RE: **Lot 5 Block 10 Unit 5 Volcano Cliffs SAD 227**
7905 Marigold NW
Grading and Drainage Plan
Engineers Stamp Date 8/31/17 (E10D35)

Based upon the information provided in your submittal received 8/31/17, this plan is approved for Grading Permit.

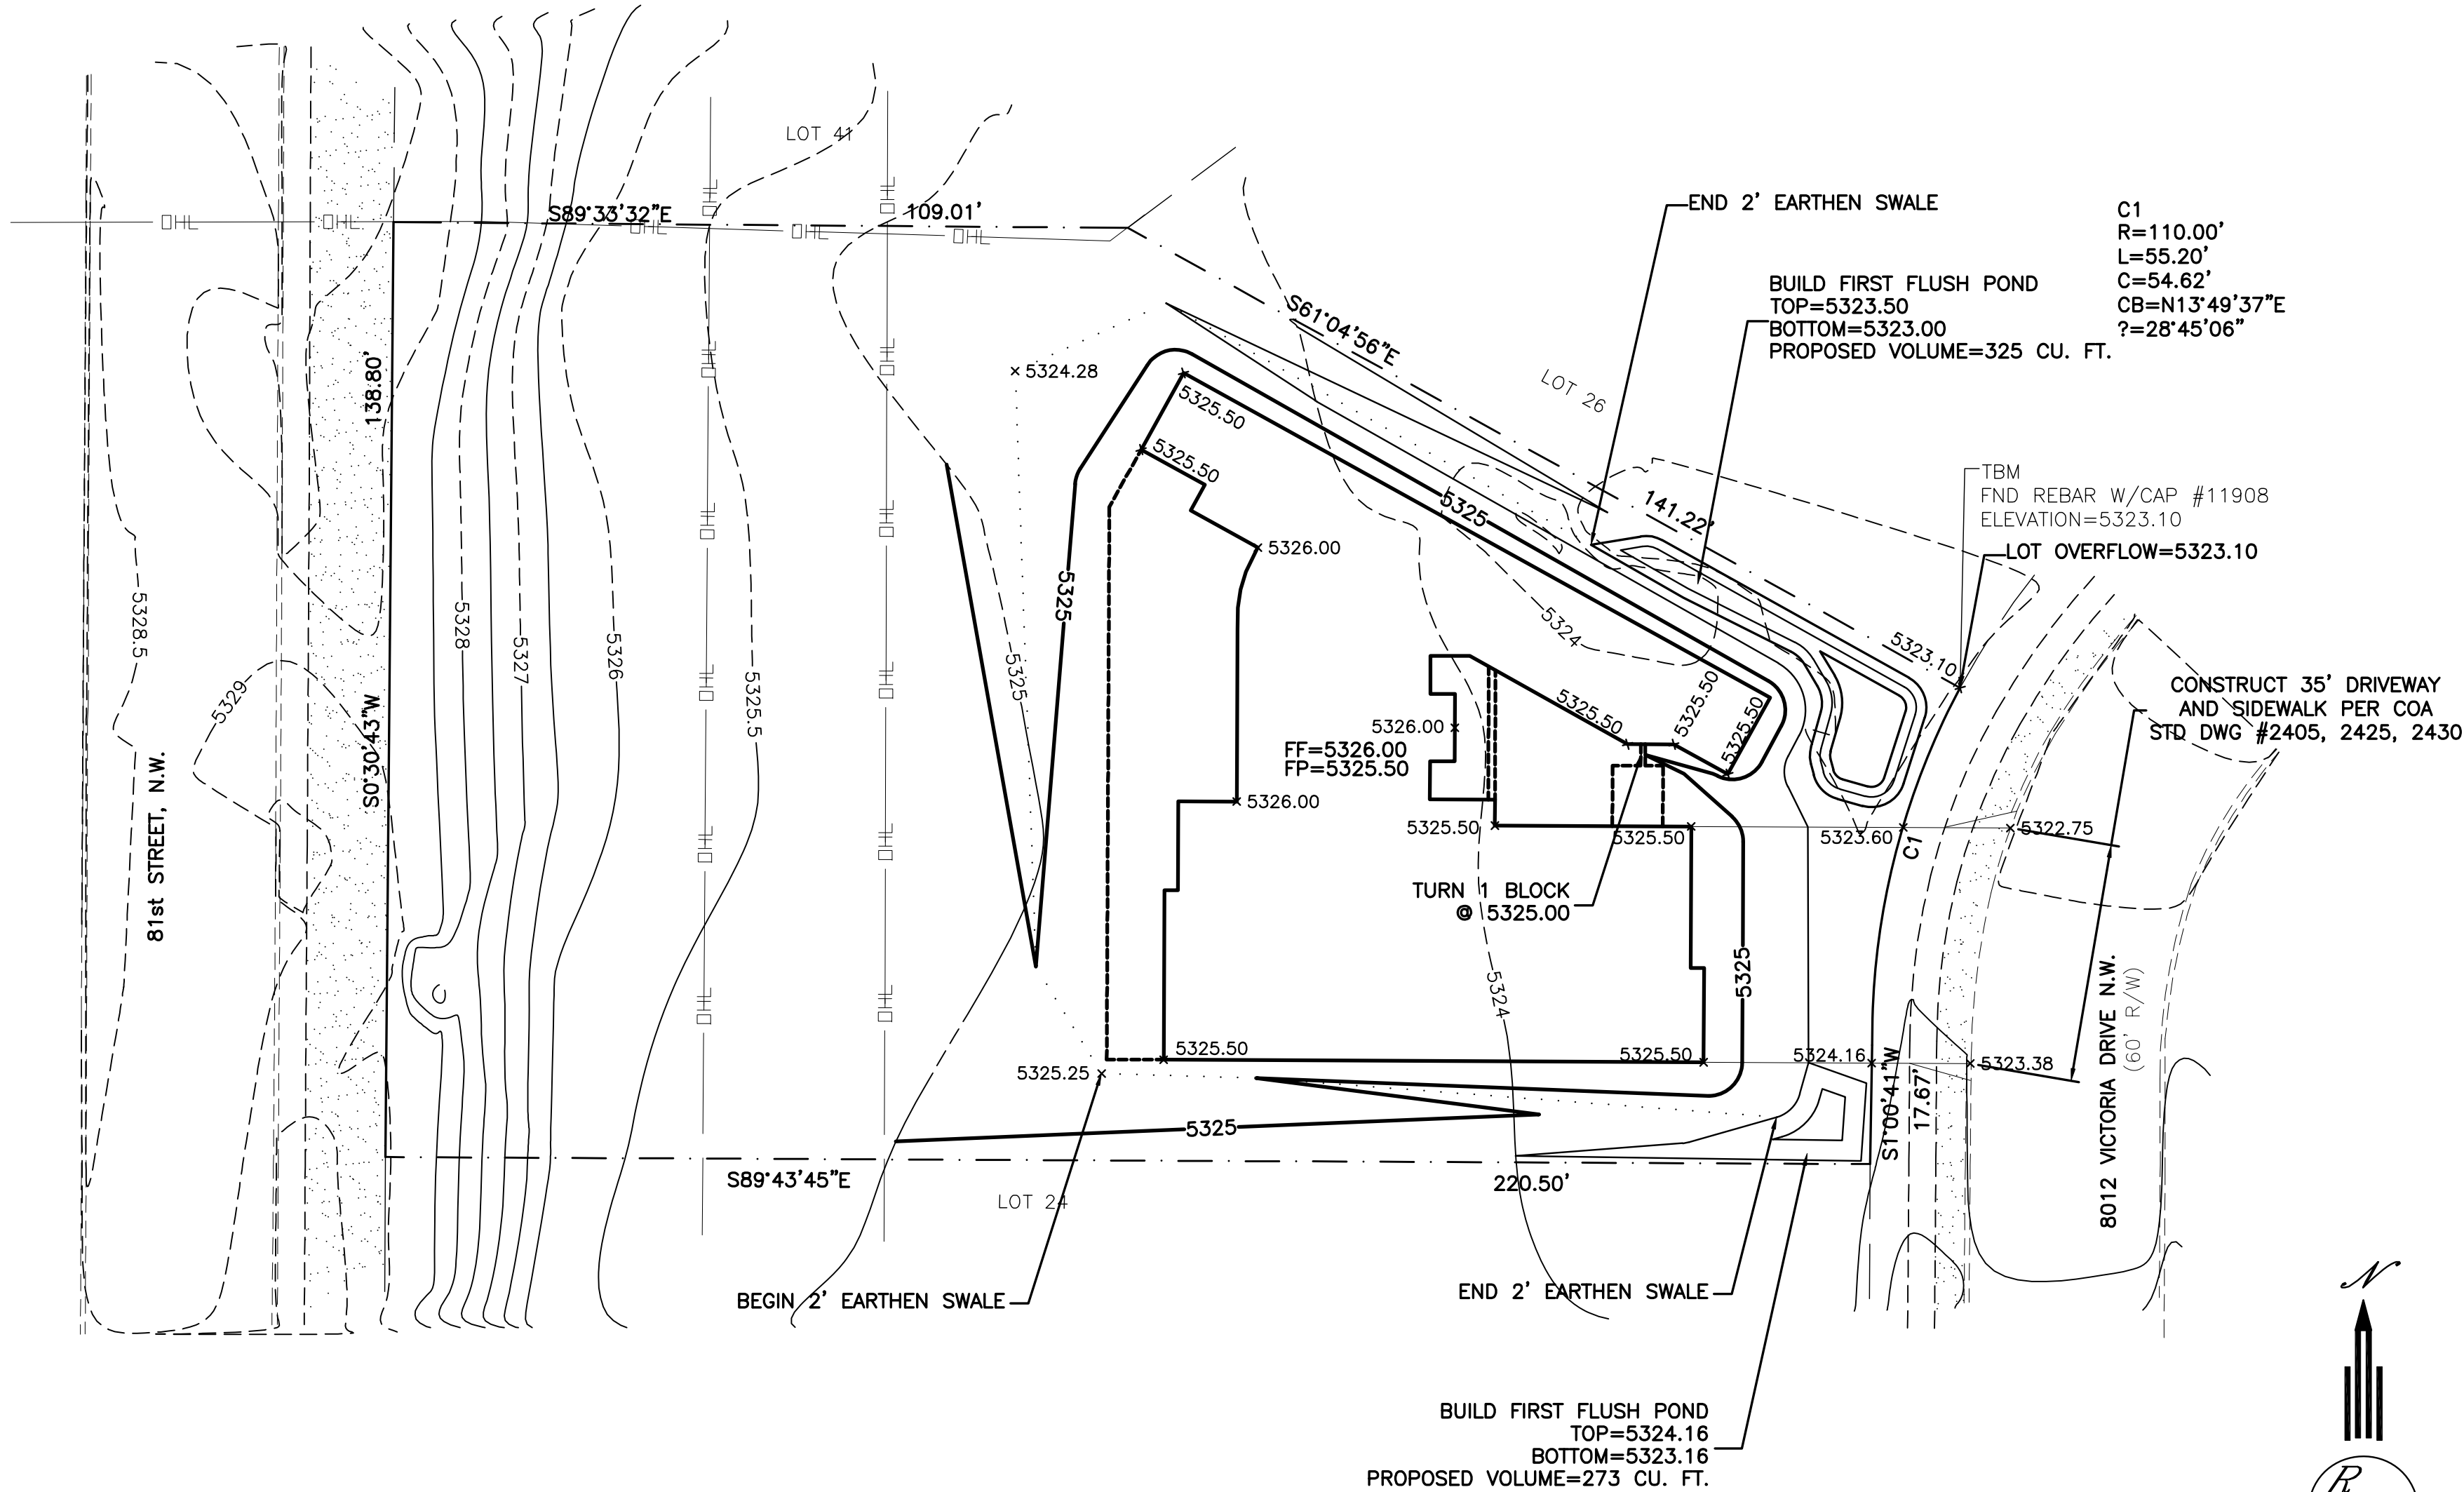
Reiterate to the Owner/Contractor that a separate permit for a garden/retaining wall must be obtained, with the approved G&D plan dated 8/31/17.

Prior to Building permit approval a Pad Certification will be required, provided by the Engineer or a registered Land Surveyor.

Prior to Certificate of Occupancy release, Engineer Certification per the DPM checklist of this plan will be required.
